REPORT AMENDED BY CPC 2-14-91
 CITY PLANNING COMMISSION
 1231 "I" STREET, SUITE 200, SACRAMENTO, CA 95814

APPLC. NO. P90-460

MEETING DATE February 14, 1991

SUBJECT: PANATTONI DEVELOPMENT COMPANY, 8401 JACKSON ROAD
TRANSPORTATION MANAGEMENT PLAN (TMP) (P90-460)

EXHIBIT A SITE PLAN

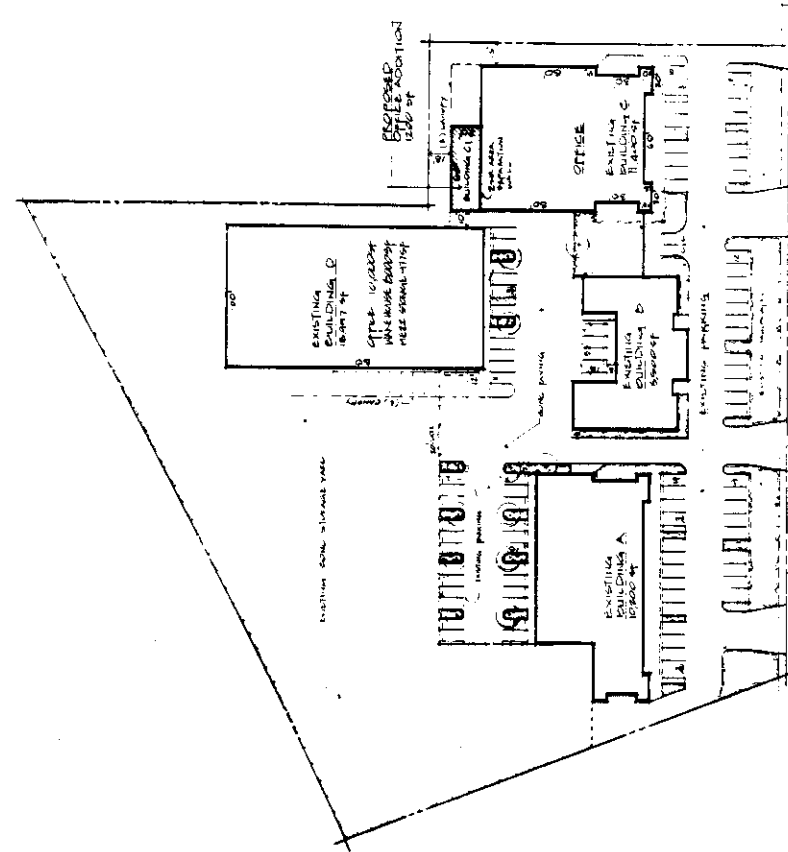
All required improvements on the site are existing. The applicant proposes to modify the existing site plan by adding a 60' X 20' addition to the rear of Building C. The addition will place Building C 10 feet from Building D (Exhibit A). No door openings are proposed on the west elevation of the proposed addition. The addition will not encroach into any setback or parking areas. All other modifications to this site will be interior tenant improvements.

The submitted site plan does not indicate the location of a trash enclosure. Trash dumpsters located outside the buildings will be required to meet the Zoning Ordinance requirements for trash enclosures.

The submitted plans indicate 104 parking spaces. The proposed use requires 101 parking spaces. Adequate parking is provided on site to accommodate the office and warehouse development of the entire site. The plans do not indicate any bicycle parking. Staff recommends that seven bicycle parking spaces (1:15 parking spaces) be added to the site due to the shift from warehouse to office use. The site is within 400± feet of the College Greens Light Rail Station. Access to the light rail station is not provided from the site. The people using the light rail station will be required to around the adjacent site to the light rail station located on Folsom Boulevard. Staff recommends vanpools to the light rail station. Implementation of a Transportation Management Plan (TMP) will be required prior to issuance of building permits. Trip reduction measures such as transit passes, carpool/vanpool and showers and lockers on the site may be required. Processing time for approval of a TMP may take up to 60 days. Therefore it is advisable that the applicant obtain the necessary TSM processing application in

EXHIBIT A SITE PLAN

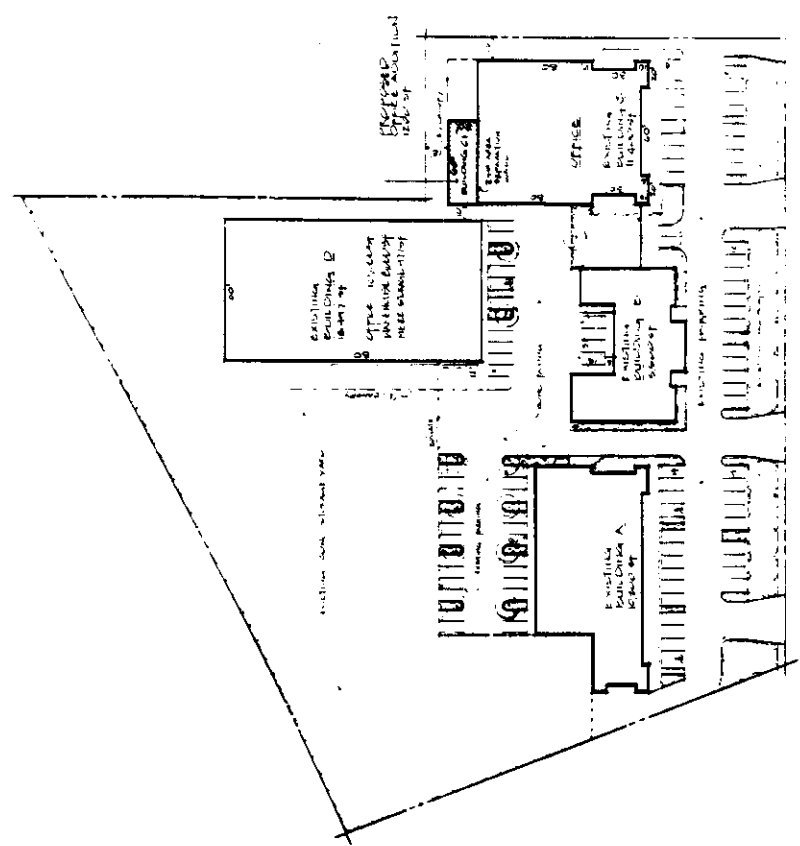
All required improvements on the site are existing. The applicant proposes to modify the existing site plan by adding a 60' X 20' addition to the rear of Building C. The addition will place Building C 10 feet from Building D (Exhibit A). No door openings are proposed on the west elevation of the proposed addition. The addition will not encroach into any setback or parking areas. All other modifications to this site will be interior tenant improvements.

The submitted site plan does not indicate the location of a trash enclosure. Trash dumpsters located outside the buildings will be required to meet the Zoning Ordinance requirements for trash enclosures.

The submitted plans indicate 104 parking spaces. The proposed use requires 101 parking spaces. Adequate parking is provided on site to accommodate the office and warehouse development of the entire site. The plans do not indicate any bicycle parking. Staff recommends that seven bicycle parking spaces (1:15 parking spaces) be added to the site due to the shift from warehouse to office use. The site is within 400± feet of the College Greens Light Rail Station. Access to the light rail station is not provided from the site. The people using the light rail station will be required to around the adjacent site to the light rail station located on Folsom Boulevard. Staff recommends vanpools to the light rail station. Implementation of a Transportation Management Plan (TMP) will be required prior to issuance of building permits. Trip reduction measures such as transit passes, carpool/vanpool and showers and lockers on the site may be required. Processing time for approval of a TMP may take up to 60 days. Therefore it is advisable that the applicant obtain the necessary TSM processing application in advance of the building permit.
